January 11, 2022
7:00 PM
Planning Board Agenda

Public hearing on applications for Subdivision Approval (lot merger) and Site Plan Approval, three-story mixed-use residential and commercial development, 364 Main Street, submitted by O'Donnell Construction Corp.

Re: 364 Main Street, Beacon, New York
Site Plan Application – Responses to Comments

Sheet 1 of 12 - Site Plan

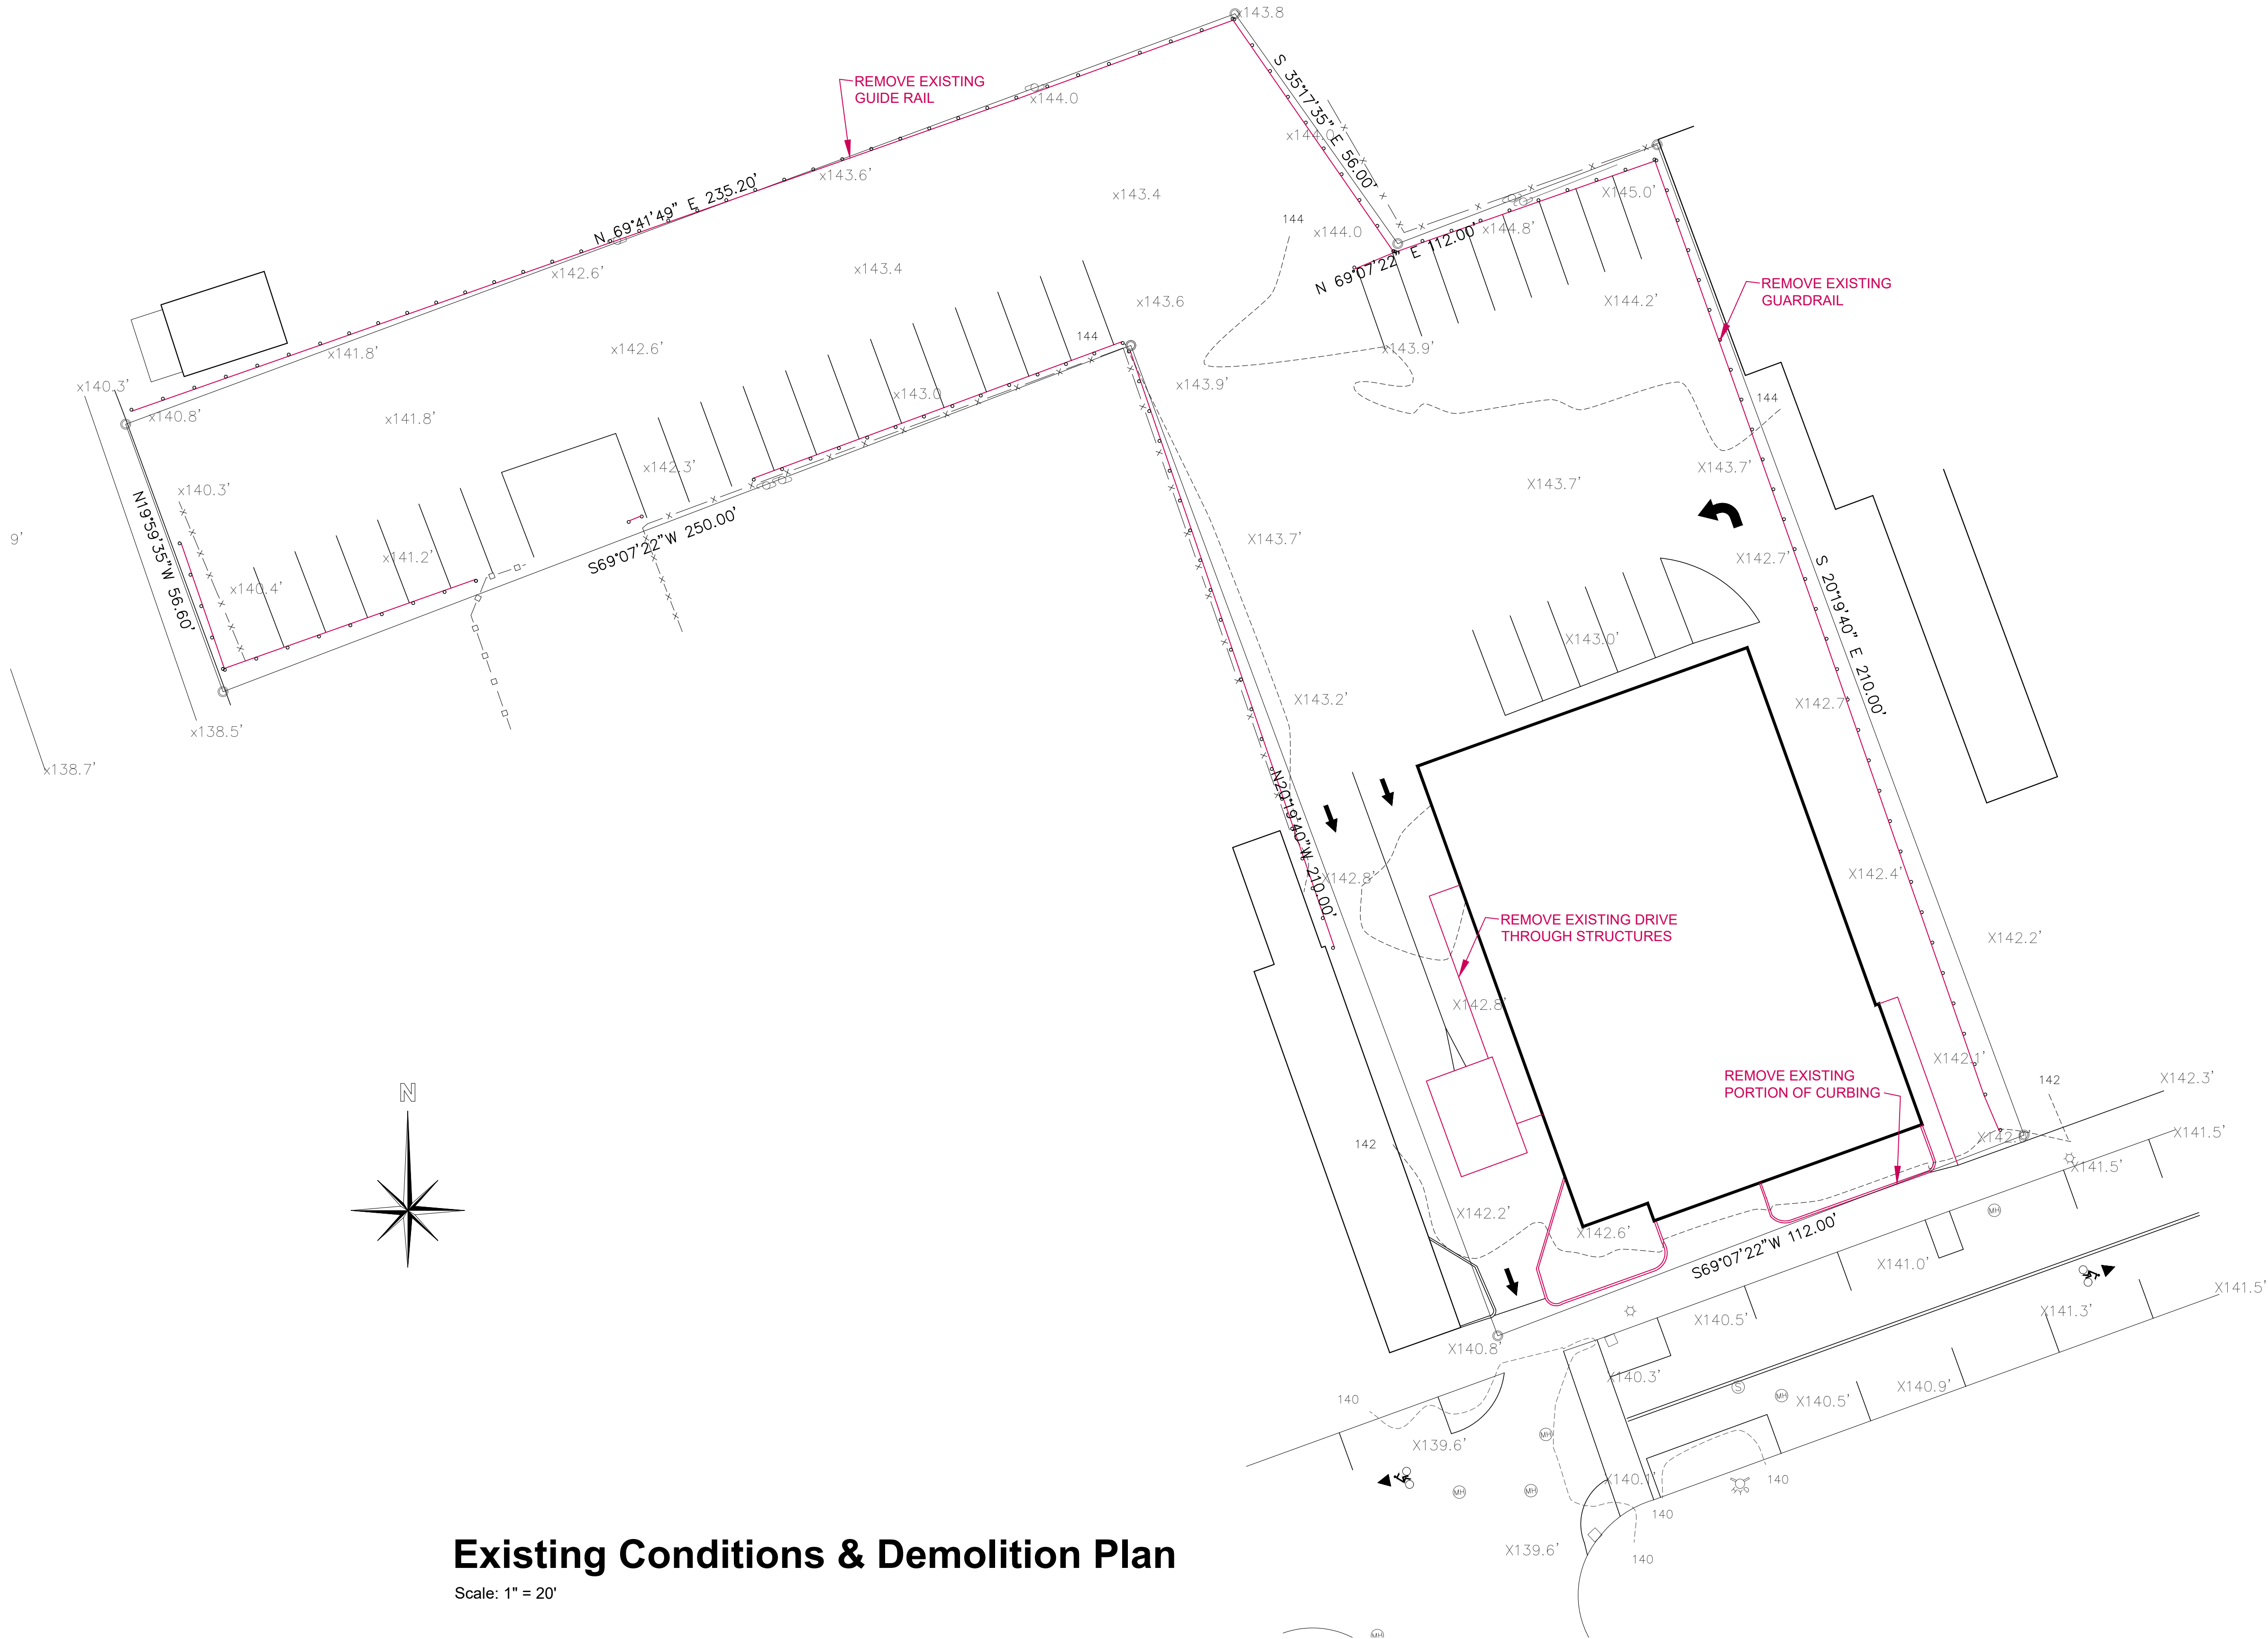
1. On the Sheet 1 Site Plan:

2. The parking table on Sheet 1 will be coordinated with the EAF, cover letter, and Sheet 4 plans.
3. Comment acknowledged. The landscape and paving in front of the building have been revised to reflect the Planning Board's stated desire to have paved space that can be used by building tenants. Benches have been added to the revised front area.

4. The tree at the Eliza Lot entrance has been correctly labeled.
5. The one way entrance drive from Main Street has been reduced to 10 feet wide along most of the length of the drive. The entrance is somewhat awkward at the 10 foot width, so the first few feet of the driveway is wider to allow for easier vehicle maneuvering. The Board determined at the December Planning Board meeting that the landscape strip should remain at the east side of the entry drive, and that the plantings within the strip be revised to make it more interesting. A pipe railing has been added to the curb along the sidewalk to provide additional protection to pedestrians along the driveway.
